APPLICANT: Washington Public Power Supply System  
FACILITY: WNP-1/4  
SUBJECT: Summary of Meeting with Washington Public Power Supply System and Babcock and Wilcox to Discuss Inadequate Core Cooling Instrumentation - July 29, 1981

AGENDA FOR SUPPLY SYSTEM/NRC MEETING  
ON INADEQUATE CORE COOLING

RCS LEVEL VS. VOLUME CORRELATION

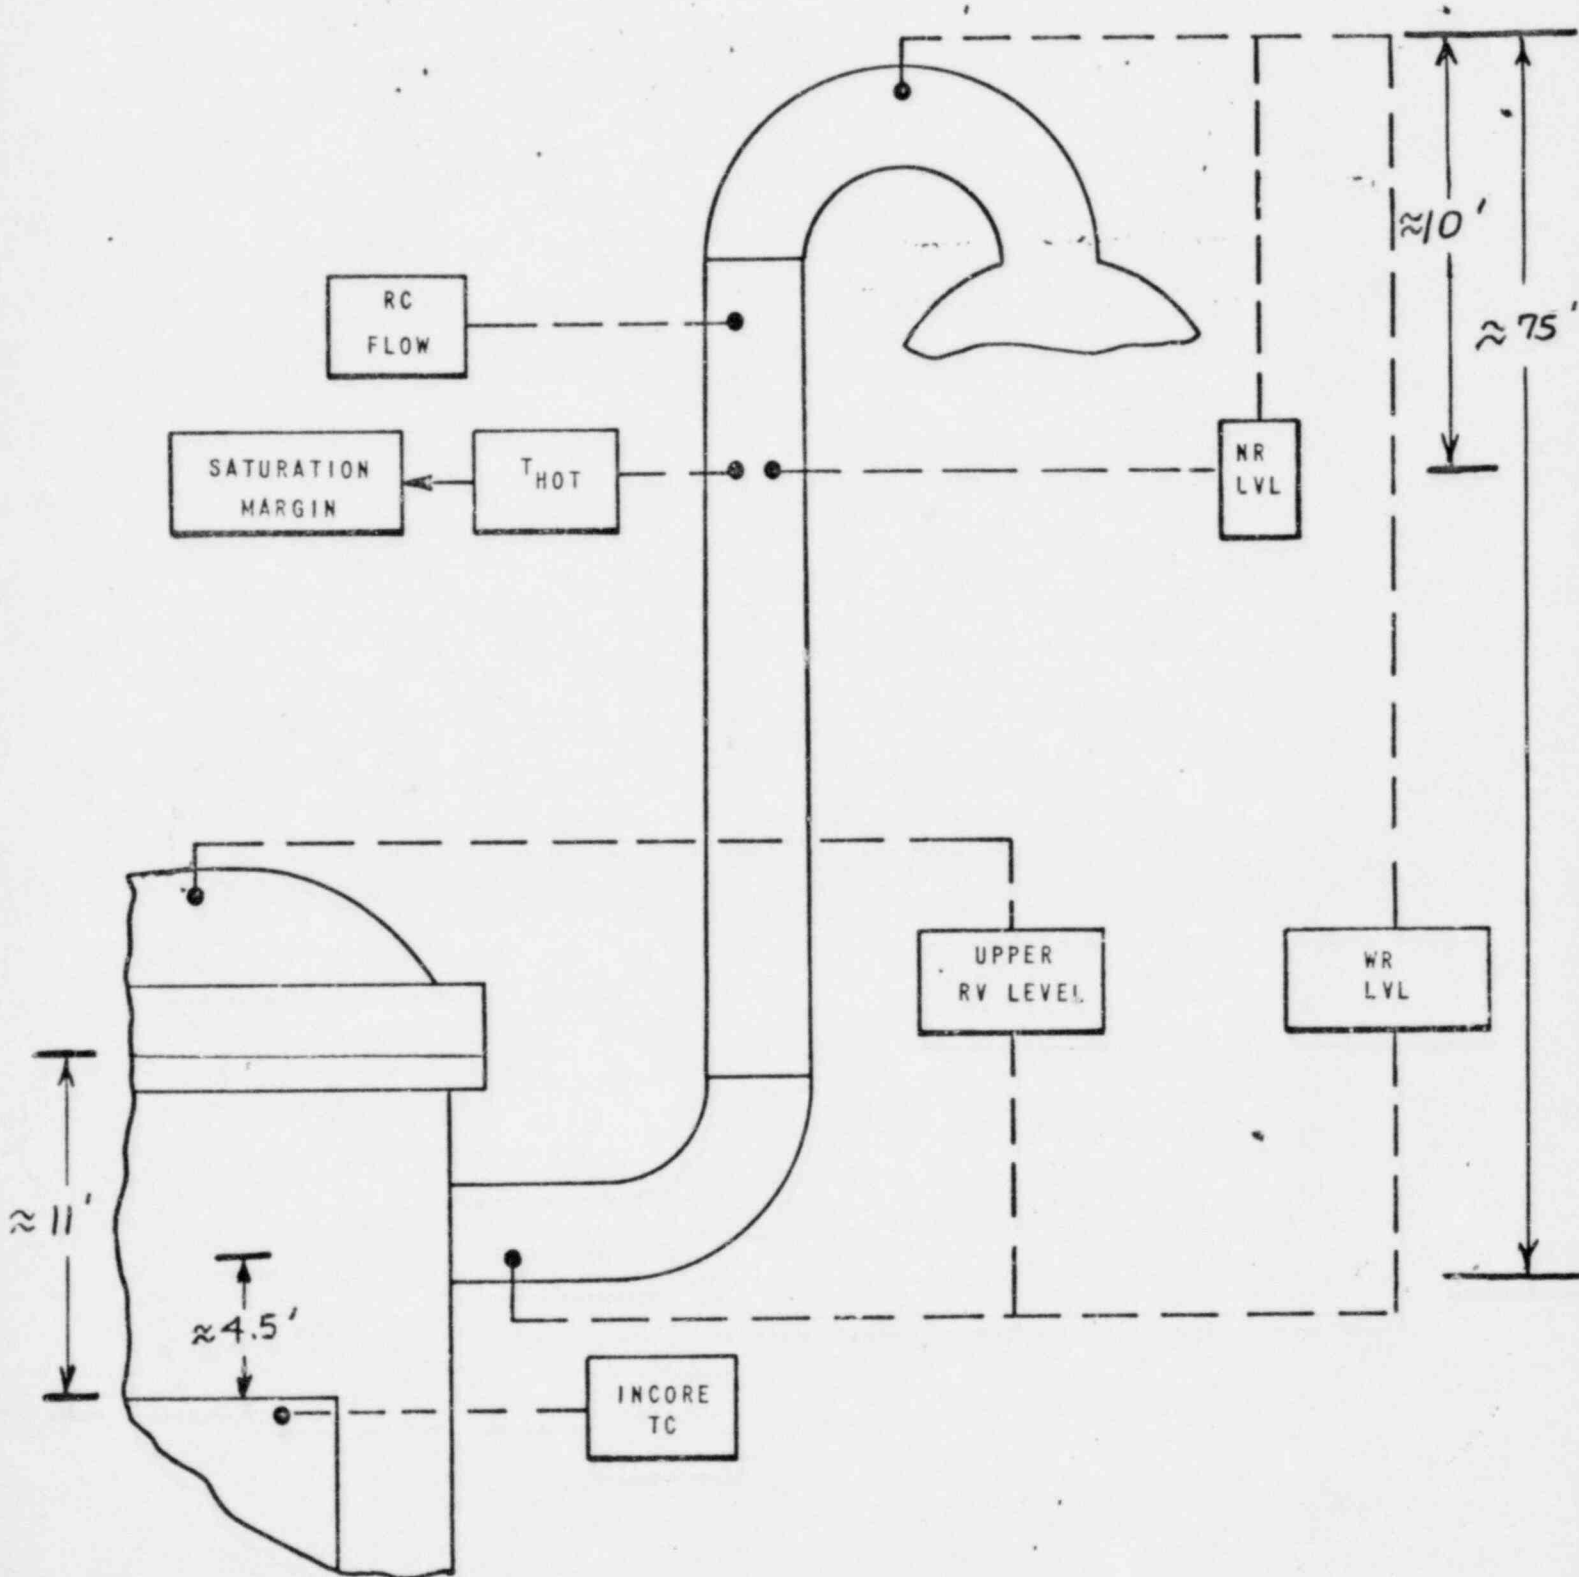
The next portion of the presentation dealt with the applicability of various core parameters and corresponding instrumentation to the various core conditions from normal operation to complete core uncover. This is shown in page 7 of Enclosure 2. A summary of RCS level vs volume demonstrated that by the time water level has dropped to a level corresponding to the bottom of the hot leg nozzles, 80% of the RCS inventory has been lost (assuming the pressurizer has drained). By comparison, with water level at 10 feet below the top of the hot leg piping (the top of the hot leg being the high point in the RCS) only 14% of the RCS has been lost assuming the pressurizer is empty (3%, with the pressurizer not empty). On this basis, the Supply System proposed use of differential pressure type level indicators on the hot leg piping as an alternative to monitoring actual reactor vessel level. Item II.F.2 states that "the evaluation is to include reactor water level indication." The design proposed by the Supply System would therefore cover a range encompassing 80% of the inventory of the RCS but would not show levels below the hot leg nozzle. The point at which fuel begins to be uncovered corresponds to an 84% loss of RCS inventory at which time incore thermocouples would clearly indicate inadequate core cooling. Therefore only a "dead band" of 4% RCS inventory would exist between the low range of hot leg level indication and commencement of core uncover. (See pages 8 and 9 of Enclosure 2).

R.C. INVENTORY DISPLAYS

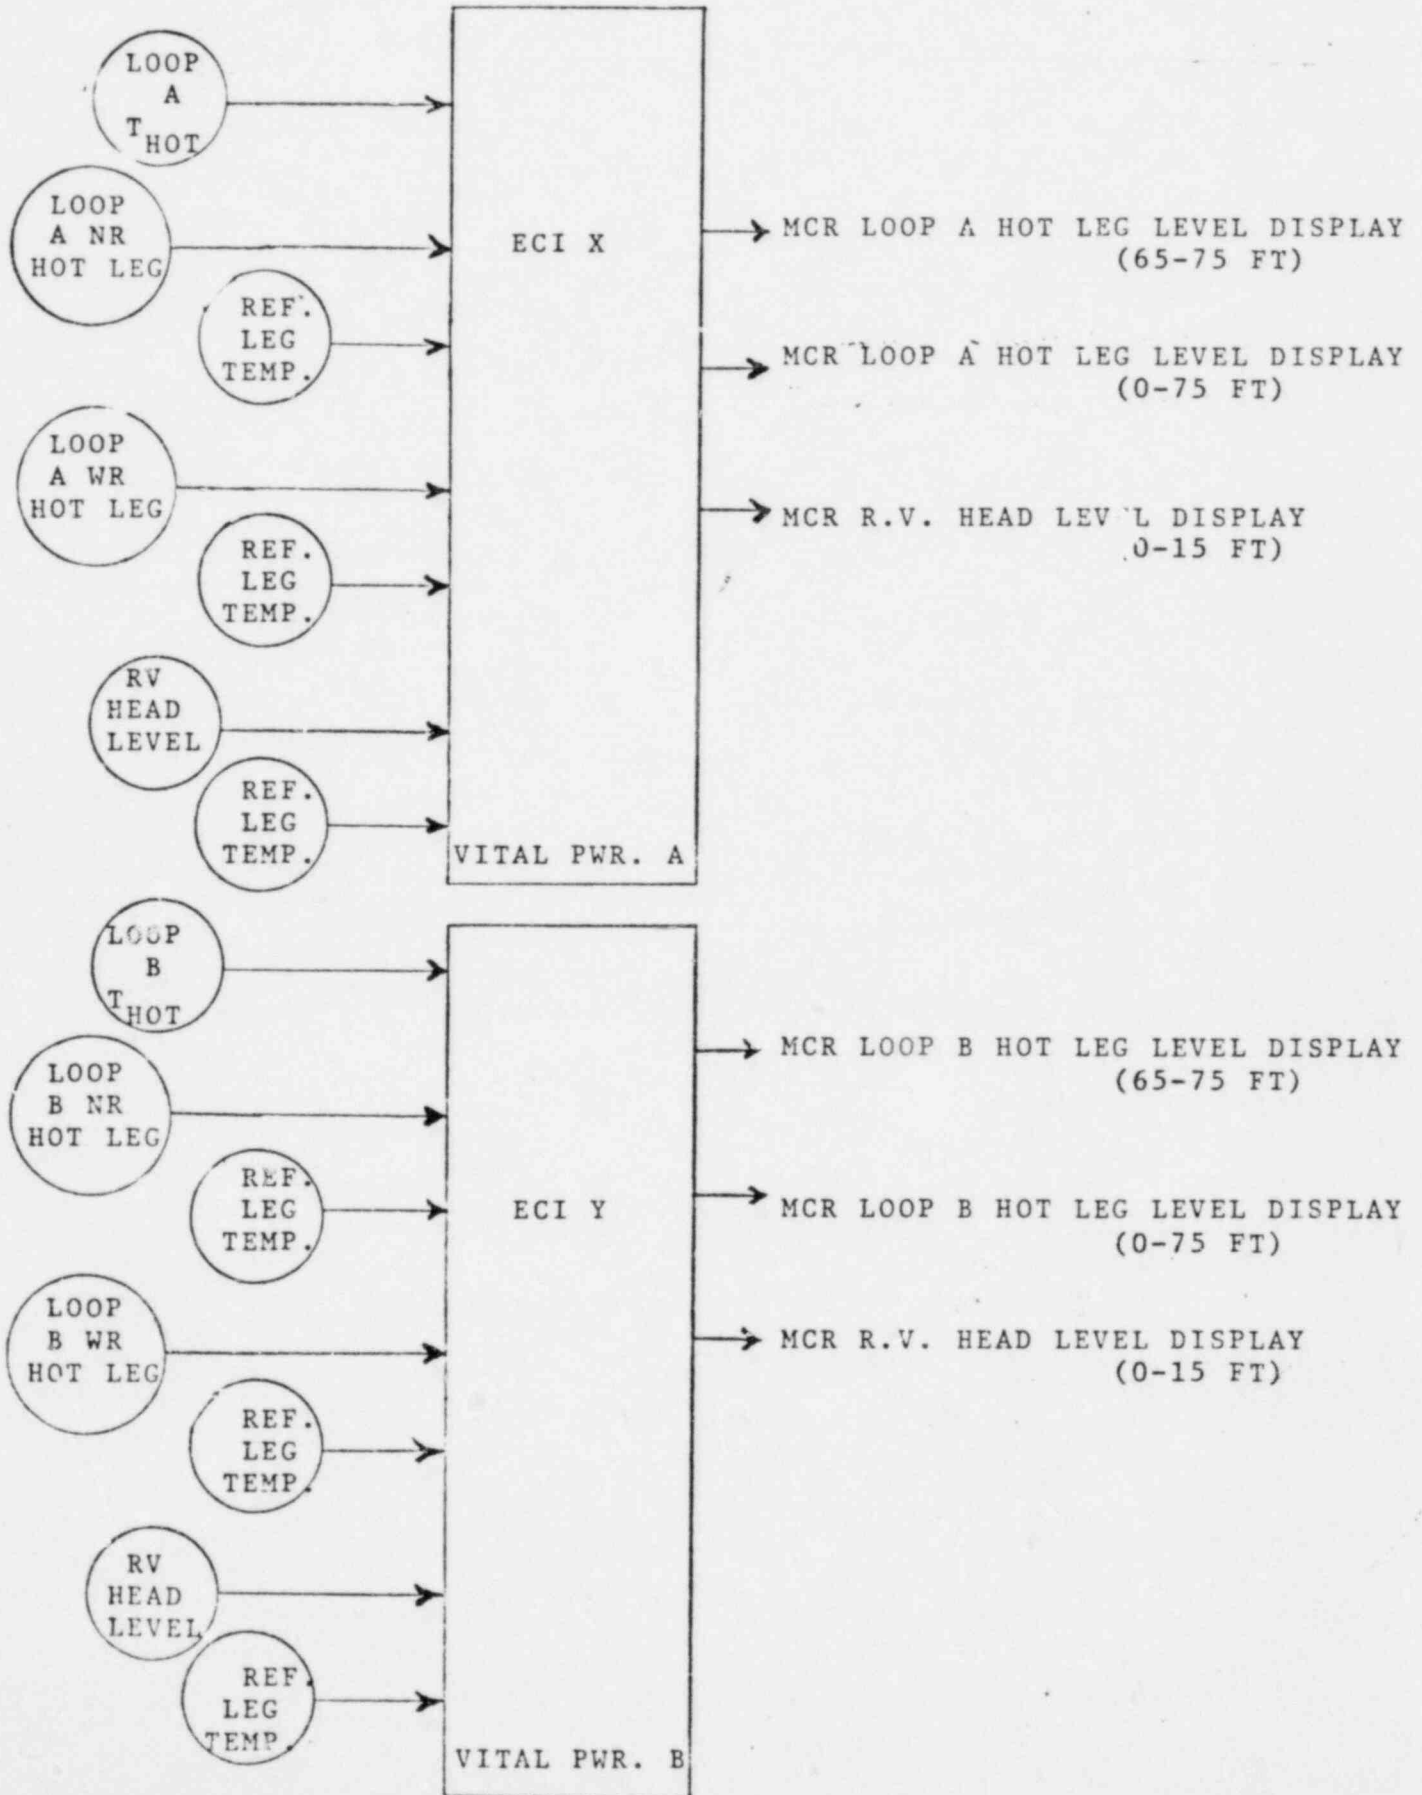
The staff raised the question of what system testing and qualification steps were planned in addition to environmental qualification of the individual components. The Supply System stated that only environmental testing/qualification was planned. The staff requested an evaluation be made to determine what type of testing should be performed to verify performance of the system design. As an example, it was pointed out that the Westinghouse reactor vessel level instrumentation system developed for this purpose is being tested as a system both at the vendor's facility and at the Semiscale Test Facility in Idaho (INEL). The staff offered to pursue the availability of Semiscale for testing of the system proposed for WPPSS, if necessary.

The staff responded that, with proper design, the level measurement concept proposed would probably be acceptable to the staff.

The Supply System was requested to evaluate additional testing and qualification of the proposed hot leg level indication system. It was also requested by the staff that this system be considered for submittal by B&W as a generic package to meet the ICC instrumentation requirements.
